Re: Sac-n-Pac, Kyle Towne Center, Overhead Electric Street Crossing Request

Sac-n-Pac, Kyle Towne Center, Overhead Electric Street Crossing Request
SD-11-009

TO: Planning and Zoning Commission
FROM: Sofia Nelson, Director of Planning
DATE: April 18, 2012
SUBJECT: Goforth Dollar General Subdivision

TO: Planning and Zoning Commission
FROM: Sofia Nelson, Director of Planning
DATE: May 15, 2012
SUBJECT: Plum Creek Phase 1 Section 11C-Final Plat

Kyle Crossing/Kohler's Crossing Intersection – Facing West

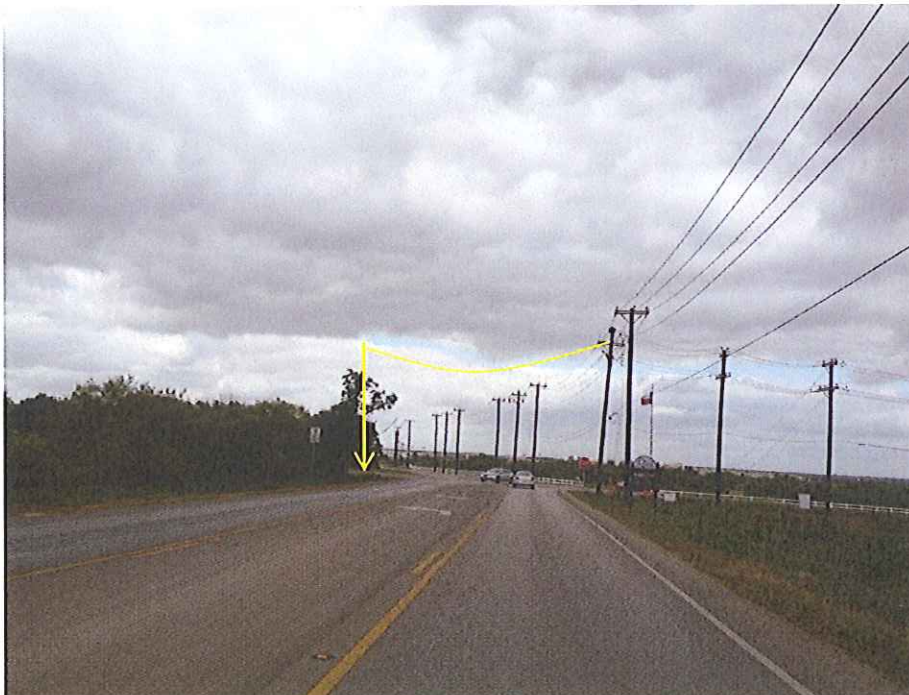
Note: new pole location shown with yellow arrow, line with yellow arc

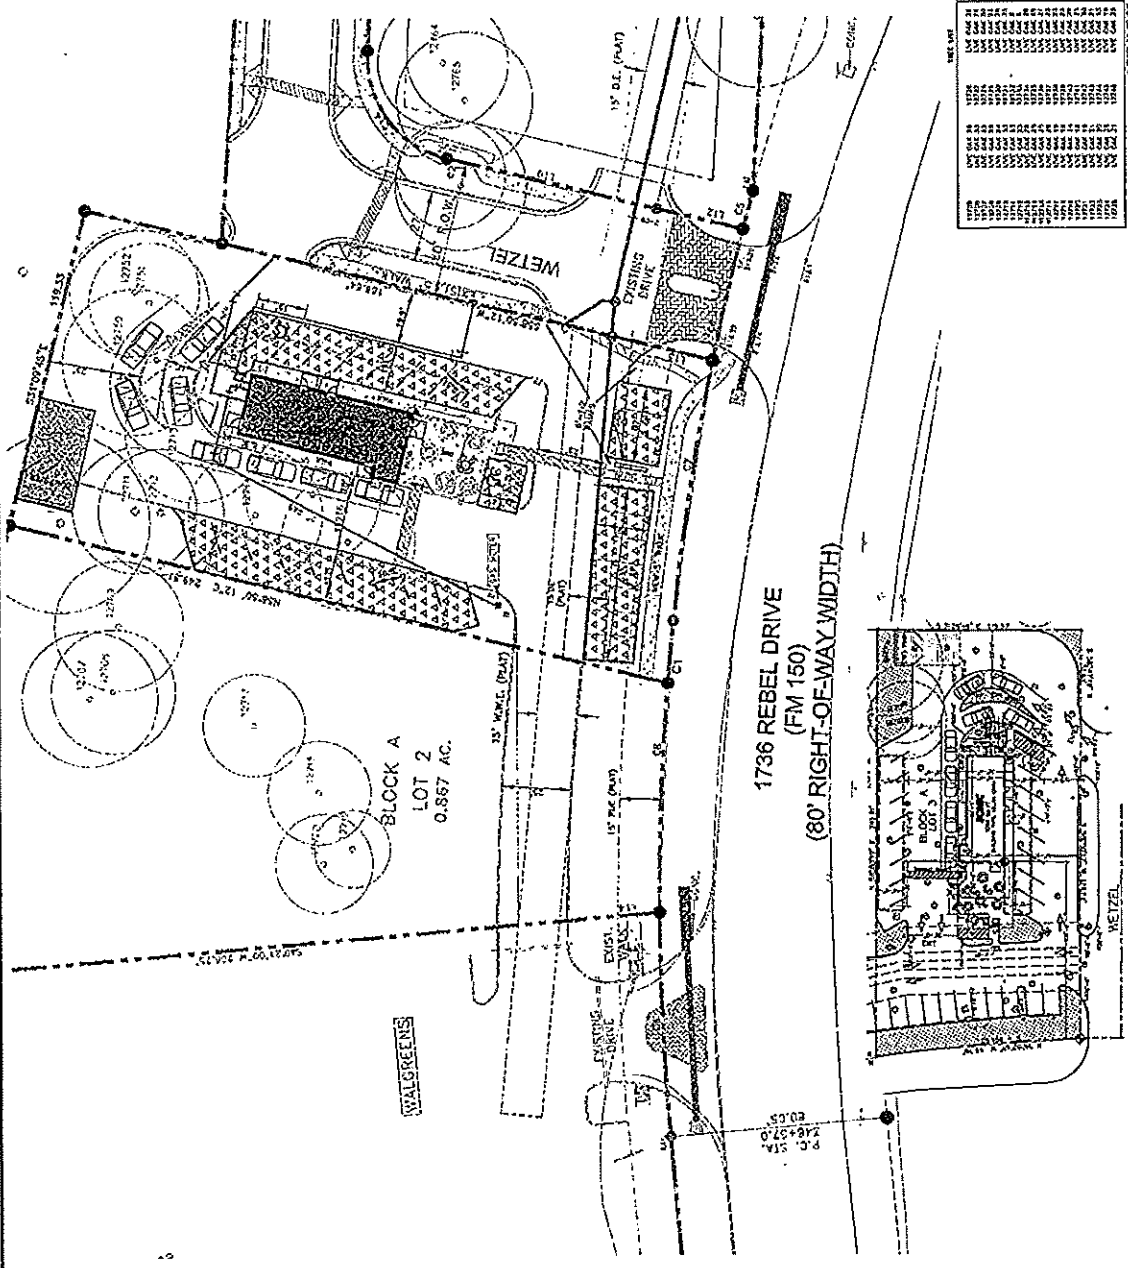
Staff has reviewed the site plan for compliance with the Plum Creek PUD and while the number and size of the trees being removed are concerning the proposed development adheres to the Plum Creek PUD requirements for development.

SITE PLAN

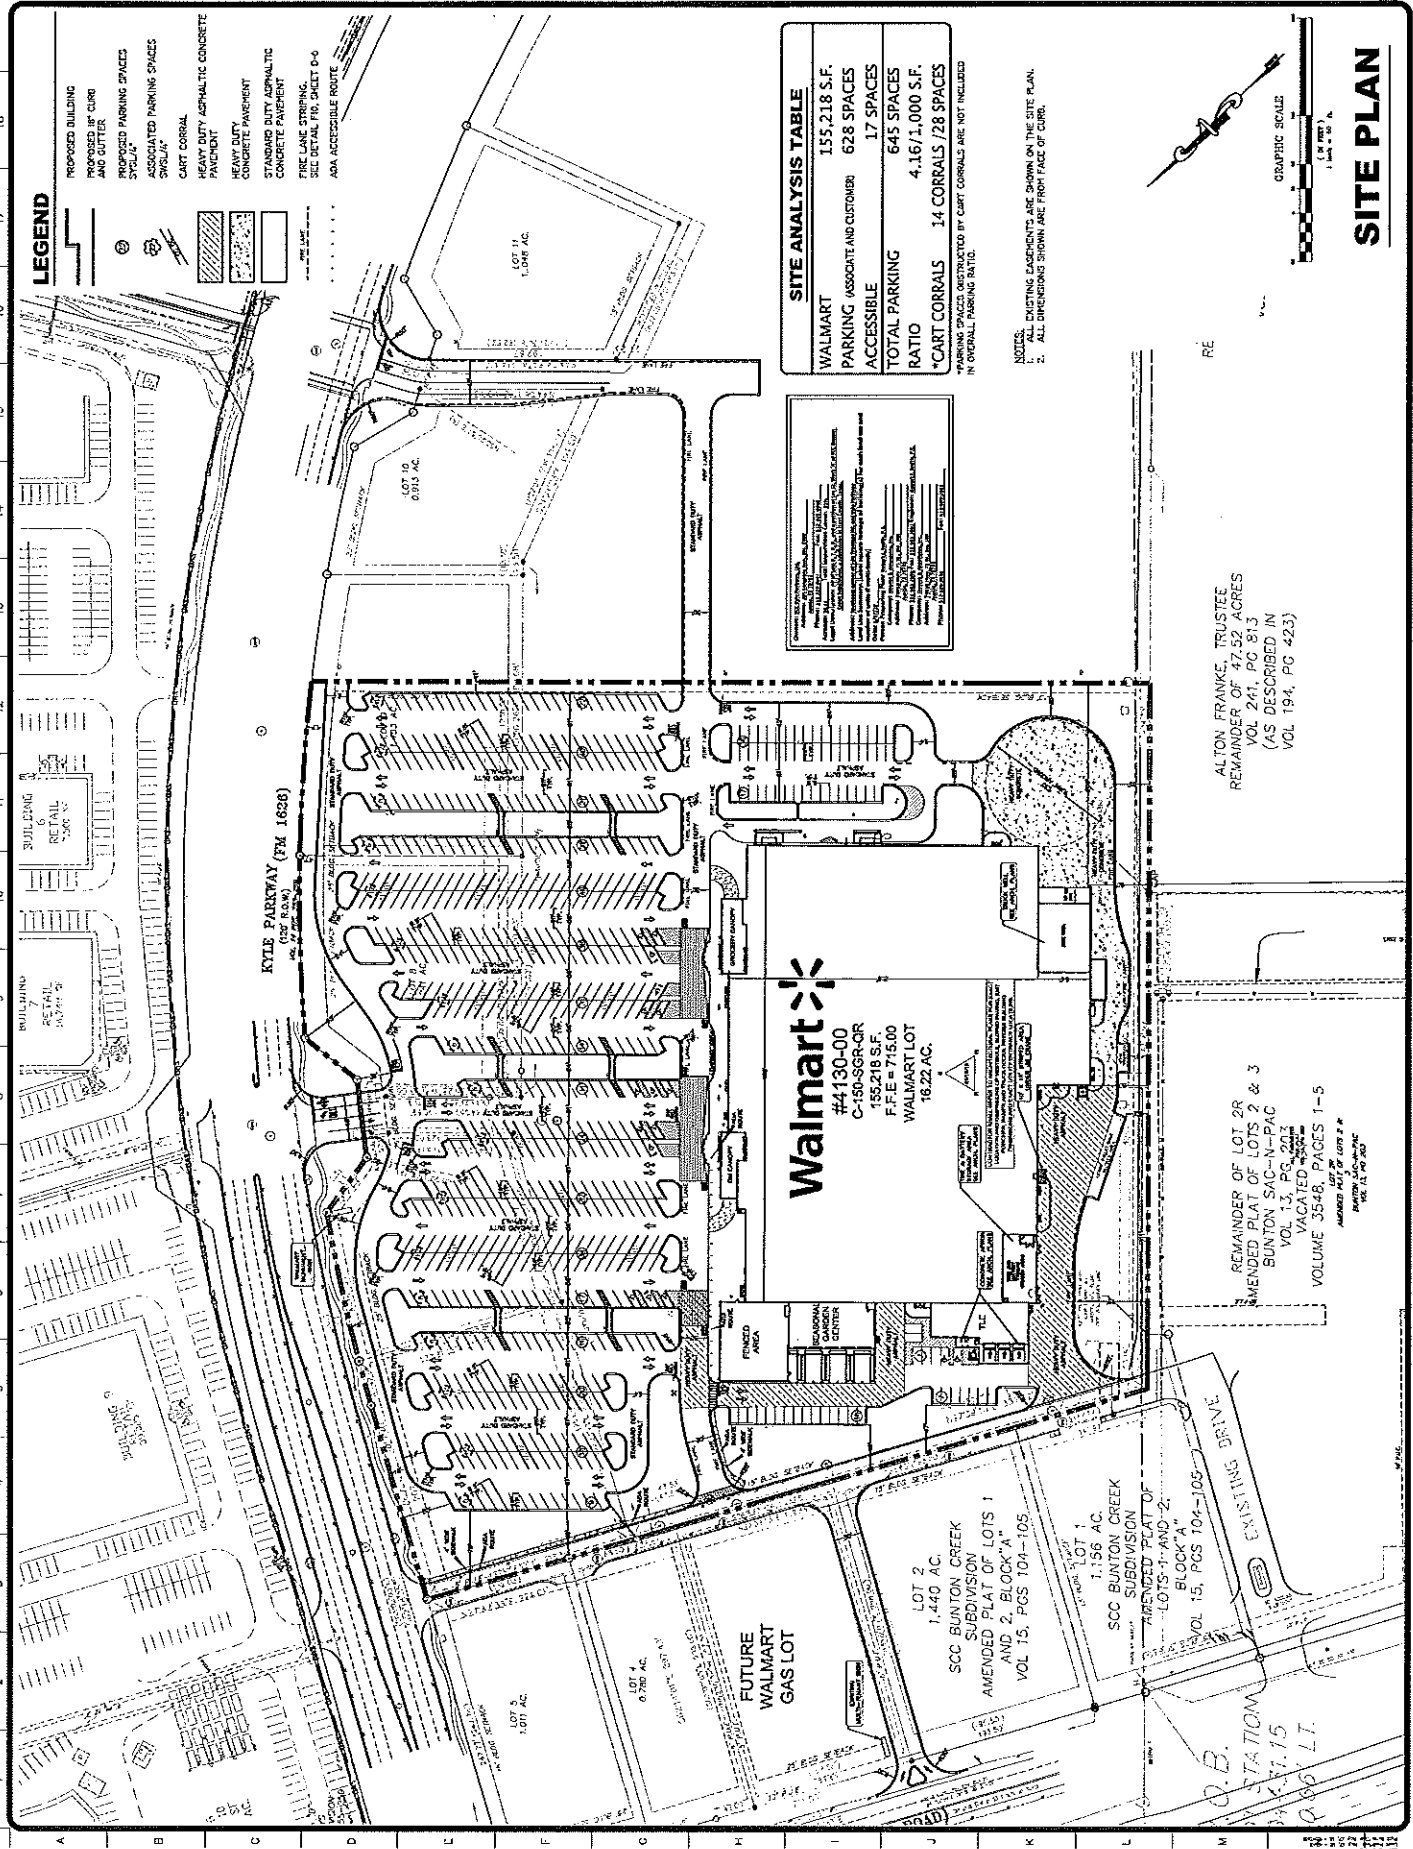
The proposed site plan is consistent with all zoning, access, parking, and landscaping requirements for the site. As mentioned above the drainage for the site is being handled via a regional detention facility. At the time of writing this staff report staff is continuing to work with the applicant to address comments issued by the city engineer. The outstanding comments are very standard in nature and the applicant has demonstrated the ability to gather the outstanding information. The requested engineering information does not impact the proposed layout of the site nor does it change any information shown on the site plan attached to this staff report.

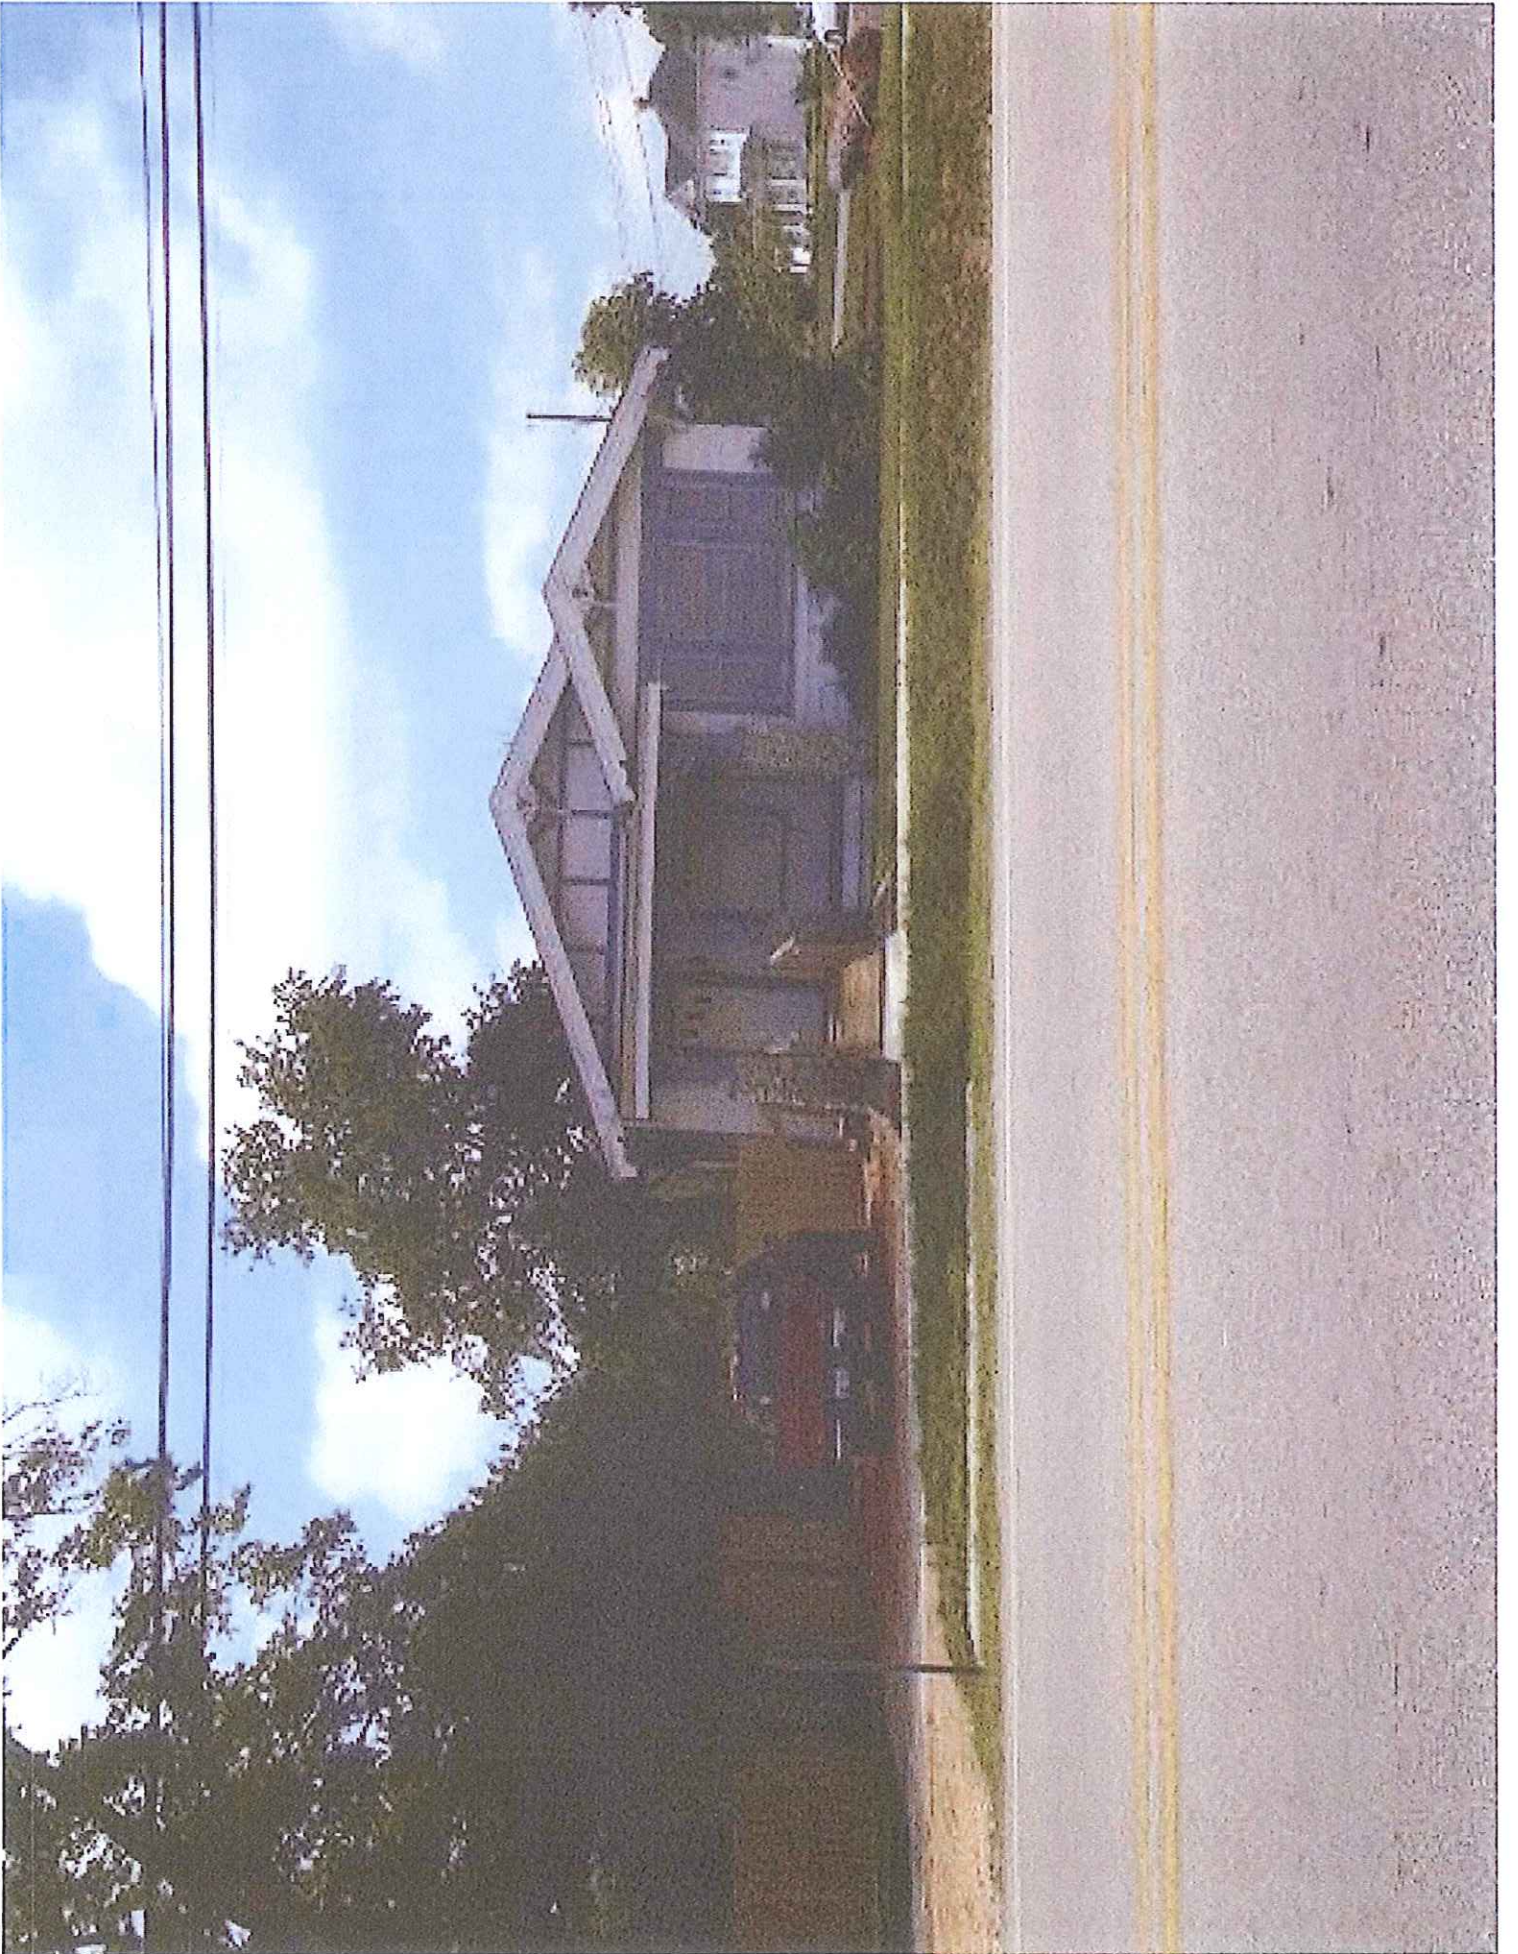
Staff has reviewed both variance requests and has made the following findings:

- Variance #1- The use of decomposed granite has many economical and environmental benefits associated with its use. While generally surrounding communities are beginning to accept the use of decomposed granite for commercial parking lots they are generally only permitted with strict compacting and bordering requirements or in areas that do not receive a lot of in and out traffic. At
